Access Compliance Report

Public Rights-of-Way

(Curb Ramps)

Intersection ID: 13085	Main Street: MORRIS_FIELD_DR	Cross Street: CAPITOL_DR	Location: SE
ADA ID: FF8C21B7B5DA	Ramp Type: Perp	Initial Pass/Fail: Fail	Overall Compliance: No
Severity Score: 8.75			
Codes/Mitigation Info/Possible Solution		Field Measurements/Component Compliance

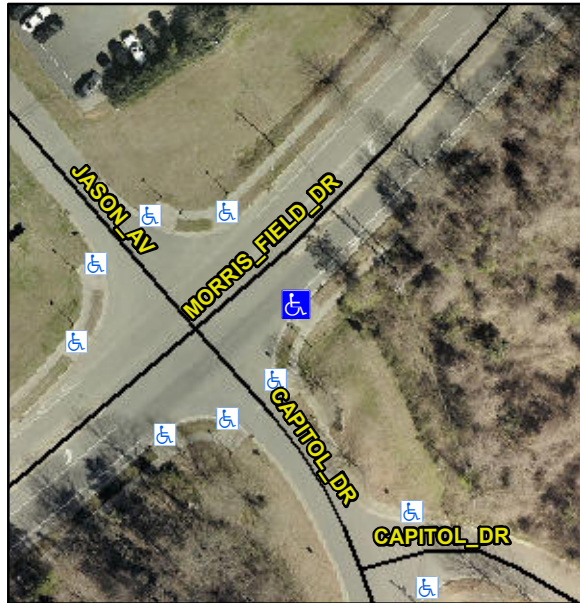
Not Found, R304.5.1

Compliance	Description	Data	Compliance	Description	Data
N/A	Ramp Length (in)	71.0	Yes	Ramp Slope (%)	5.3
No	Ramp Width (in)	47.0	Yes	Ramp XSlope (%)	0.1
N/A	Flare Type LT	N/A	N/A	Flare Type RT	N/A
N/A	Flare Slope LT (%)	N/A	N/A	Flare Slope RT (%)	N/A
N/A	Flare Traversable LT?	N/A	N/A	Flare Traversable RT?	N/A
N/A	Landing Length (in)	N/A	N/A	DWS Provided?	N/A
N/A	Landing Width (in)	N/A	N/A	DWS Contrast?	N/A
N/A	Landing Slope (%)	N/A	N/A	DWS Length (in)	N/A
N/A	Landing X Slope (%)	N/A	N/A	DWS Full Width?	N/A
N/A	Landing Curb? (Y/N)	N/A	N/A	DWS Offset (in)	N/A
N/A	Shared Landing?	N/A			
N/A	Gutter Ponding?	N/A	N/A	Gutter Slope (%)	N/A
N/A	Gutter Lip Ht (in)	N/A	N/A	Gutter X Slope (%)	N/A
N/A	Painted X Walk1?	No	N/A	Painted X Walk2?	N/A
	X Walk 1 Direction	To NW		X Walk 2 Direction	N/A
N/A	X Walk 1 Width (in)	N/A	N/A	X Walk 2 Width (in)	N/A
	X Walk 1 Slope (%)	1.6		X Walk 2 Slope (%)	N/A
	X Walk 1 X Slope (%)	1.7		X Walk 2 X Slope (%)	N/A

Remove & Replace Entire Ramp.
